3330 Piedmont Rd. NE  
Atlanta, GA 30305

November 26, 2025

STARBUCKS PIEDMONT RD & TOWER PLACE DR. – Narrative in support of the administrative variations.

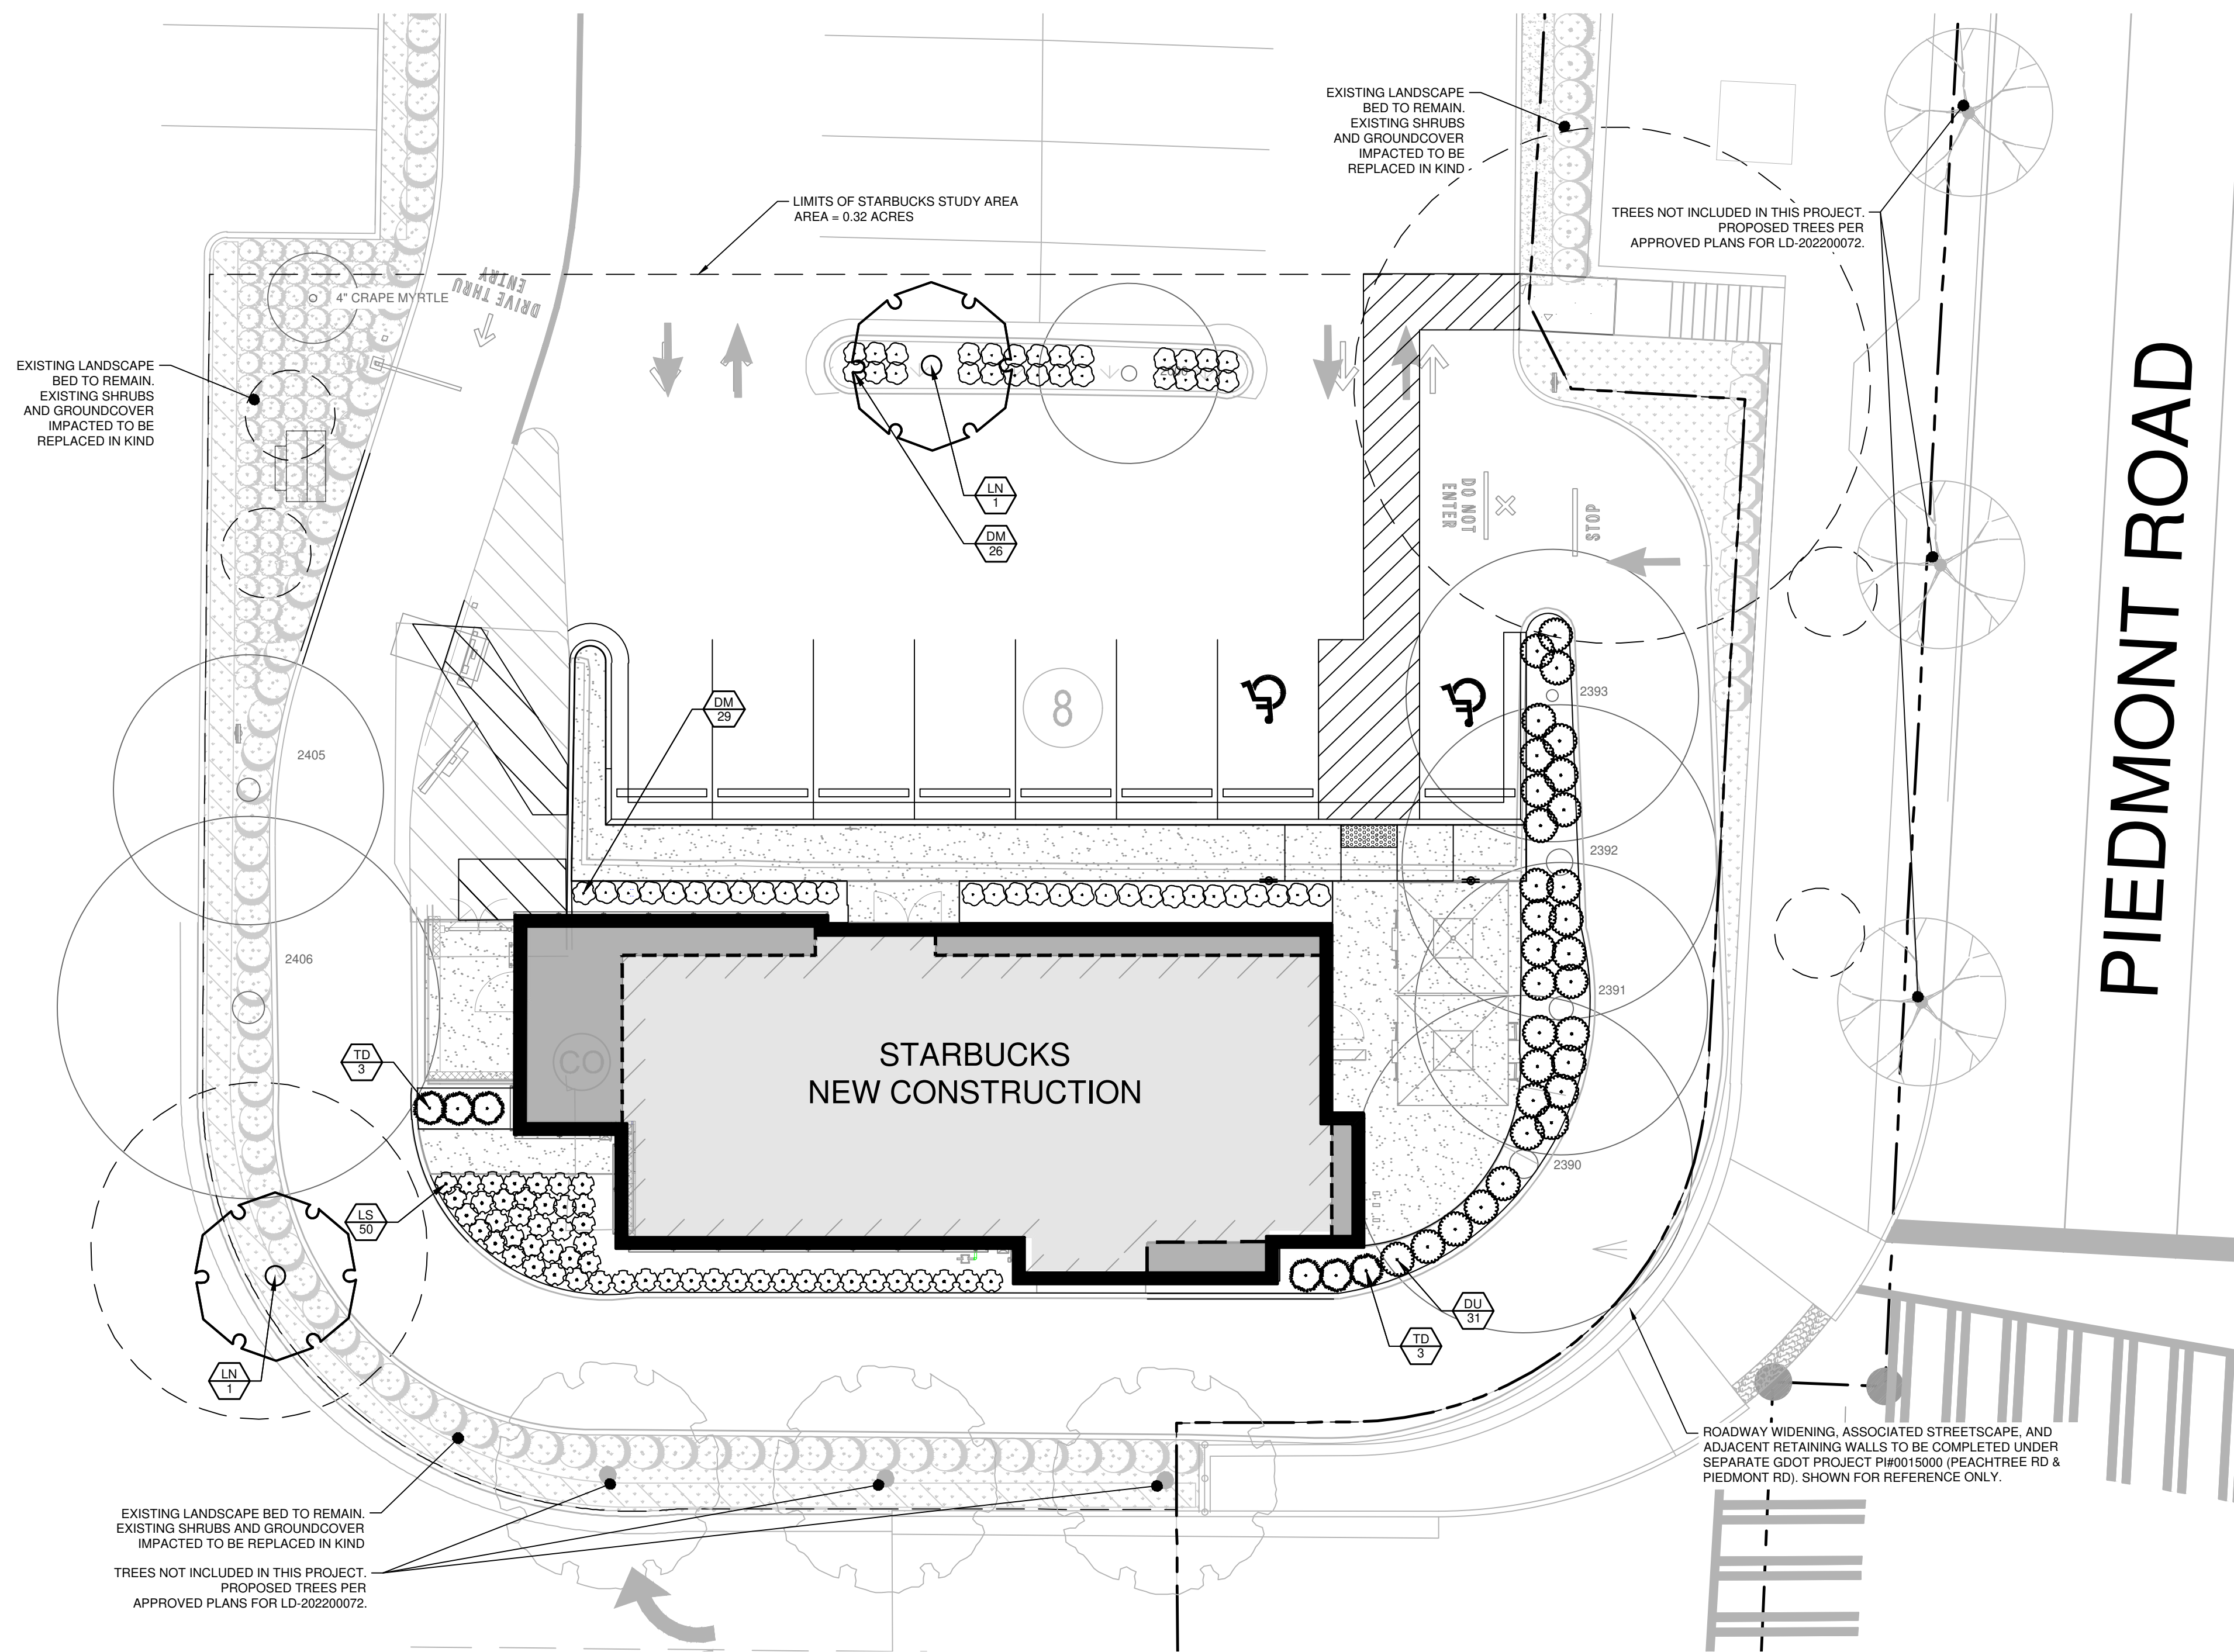
**2. Variation from the maximum setback from the street and having a lane between the building and the street:**

**Resolution:** *As part of GDOT's street widening of Piedmont Road is closer to the building.*

*Also, the retaining wall will block the view of the drive from Piedmont Road.*

3 DT BUMP ELEVATION  
Scale: 3/4" = 1'-0"

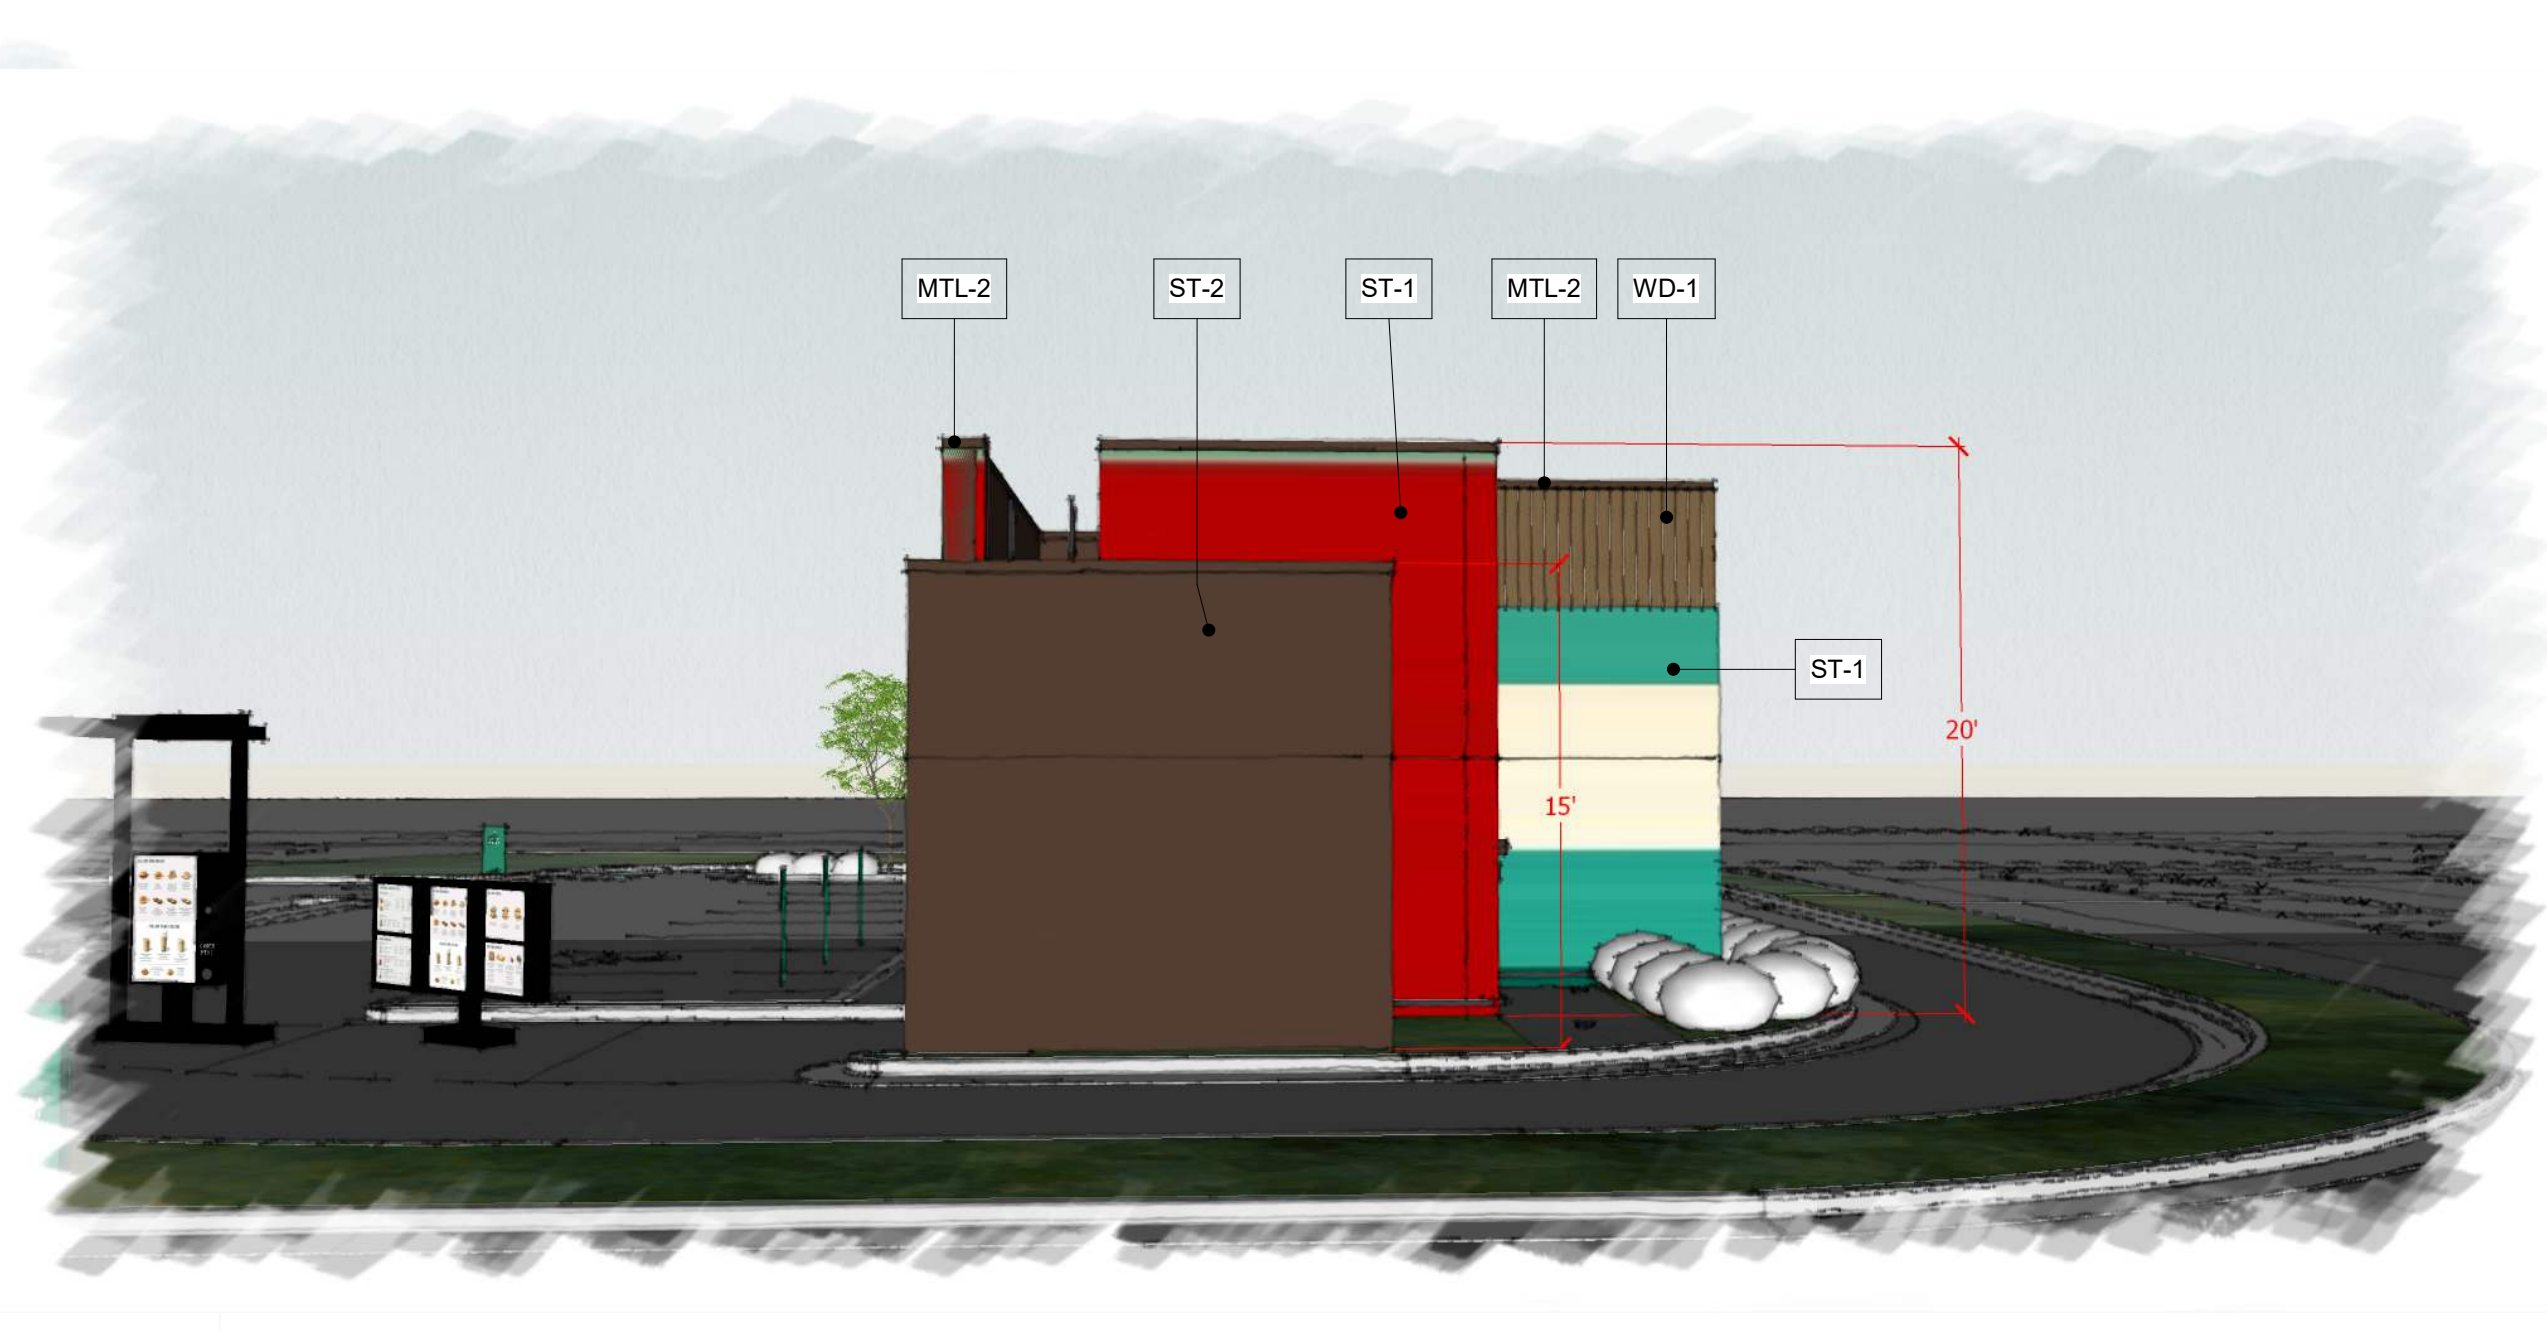
**1. View of the drive-through from Piedmont Road:**

**Resolution:** *Additional building furring has been added to the existing bump to extend the building volume to screen the bump. Taller landscaping is also provided to screen the area. View of the window is further concealed by the retaining wall constructed by GDOT.*

**1 MECHANICAL ROOF PLAN**  
Scale: 1/4" = 1'-0"

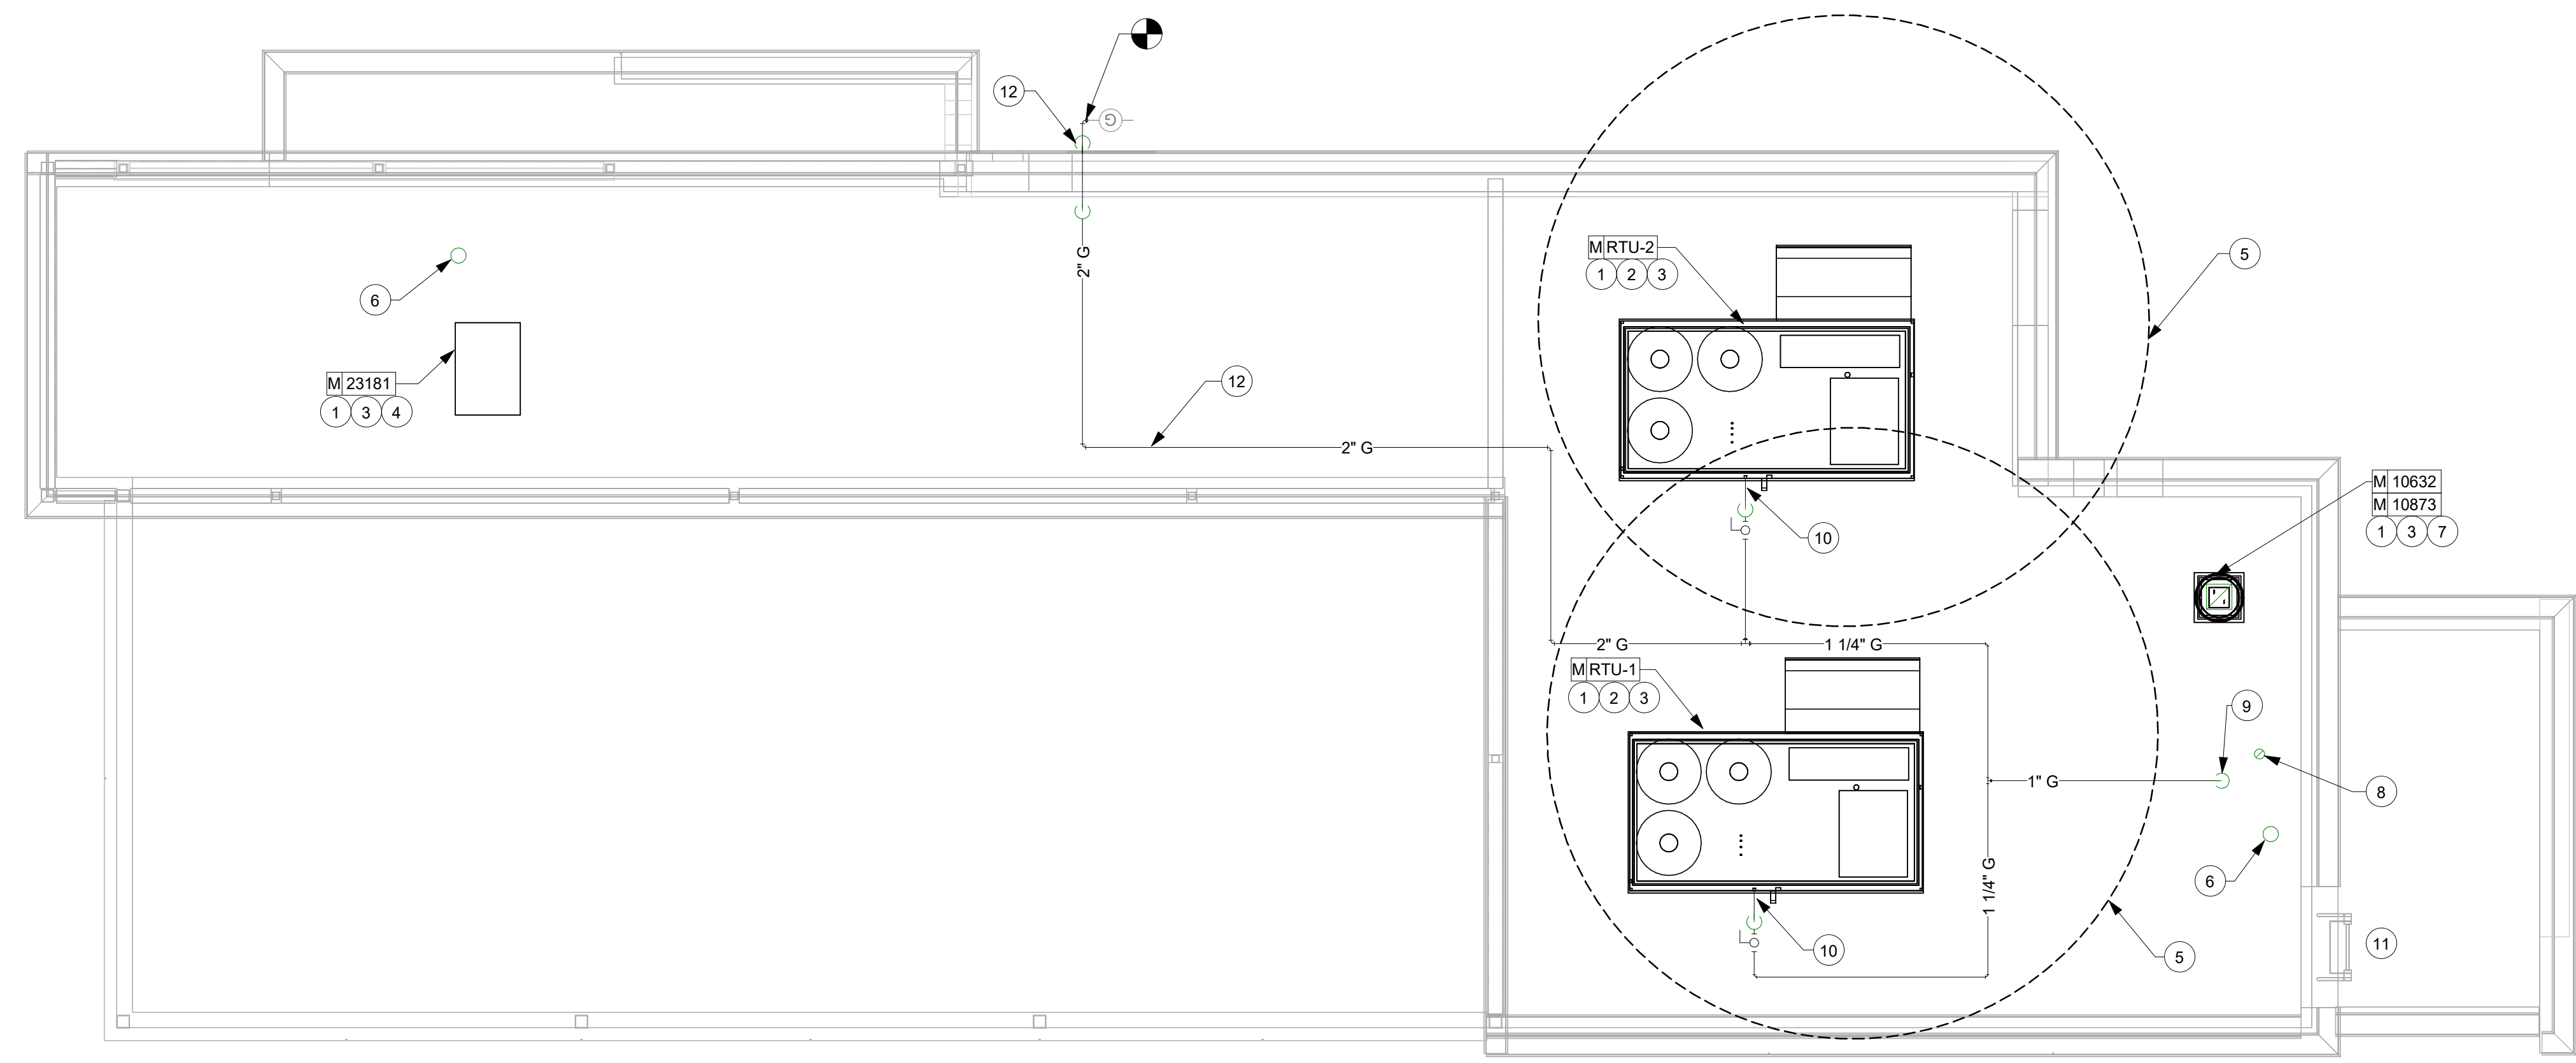
**3. Concern regarding the visibility of the HVAC equipment from Piedmont:**

**Resolution:** *Our parcel sits approximately 5 feet below Piedmont Road - the project does not alter the existing grade change. Our building's height is 20 feet. The mechanical equipment has been relocated away from Piedmont Road, towards the rear of the roof, near the other services, and is fully surrounded by a high parapet, which is taller than the original building's parapet.*
